#### REMARKS

ANNOTATED SHEET SHOWING CHANGES

ATTY DKT. NO.: APPM/008260/PPC/ECP/CKIM
U.S. SERIAL NO.: 10/680,616
FILED: OCTOBER 6, 2003
APPLICANT: APPLIED MATERIALS, INC.
TITLE: SPIN RINSE DRY CELL
INVENTORS: DONOSO, ET AL.

FIGURE 3A

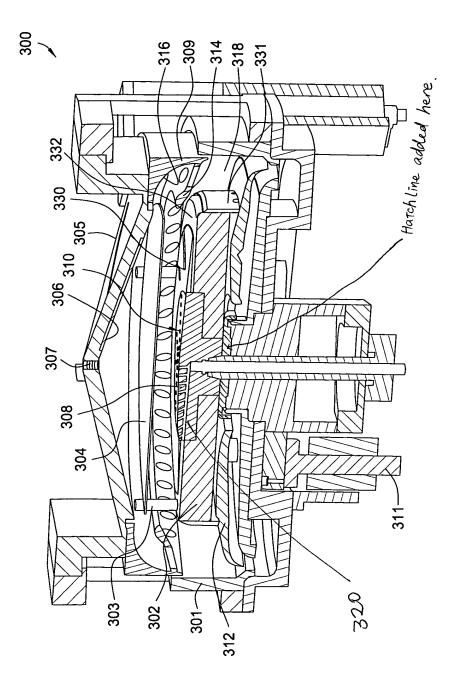
In Figure 3A, previously omitted numeral 320 and a hatch line have been added. In Figure 3B, a hatch line has been added. In Figure 3C, a hatch line and two arrows have been added. In Figure 5, previously omitted numerals 505, 521, 522, 523 and 524 have been added. In Figure 8, previously omitted numeral 810 has been added and an editorial mistake relates to numeral 839 has been corrected.

The Examiner objected to Figures 3A-C on the ground that the precise manner in which the rotatable flywheel and central hub interact cannot be clearly determined from the drawings. Applicants respectfully submit that Figures 3A-C are schematic figures which are not intended to show all the details. However, a detailed interaction between the rotatable flywheel and central hub may be found in Figure 5, which is an exploded view of a flywheel assembly of the present invention. From Figure 5, it would be clear to a person skilled in the art that how the flywheel assembly works. Nevertheless, Applicants added reference numerals 521-524 and a short description of the numerals in paragraph [0049] for further explanation.

FIGURE 3B

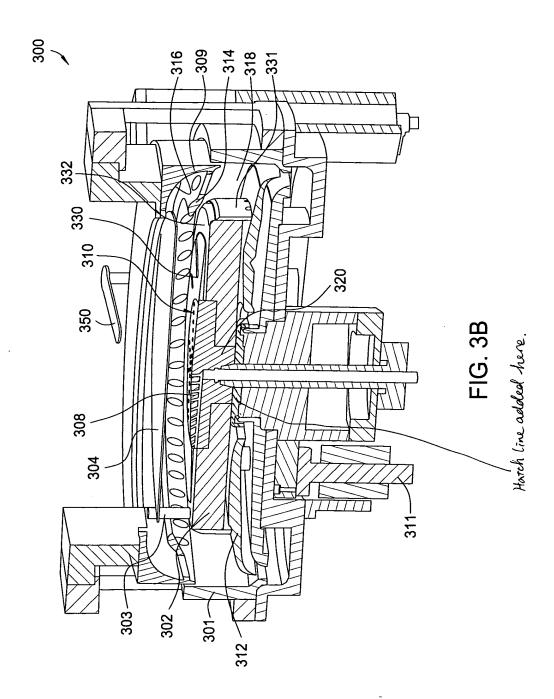
The Examiner indicates that reference number 311 in Figures 3B and 3C is not mentioned in the description. Applicants submit that the number 311 was omitted in paragraphs [0040] and [0048] due to editorial errors and proper amendments have been made to paragraphs [0040] and [0048].
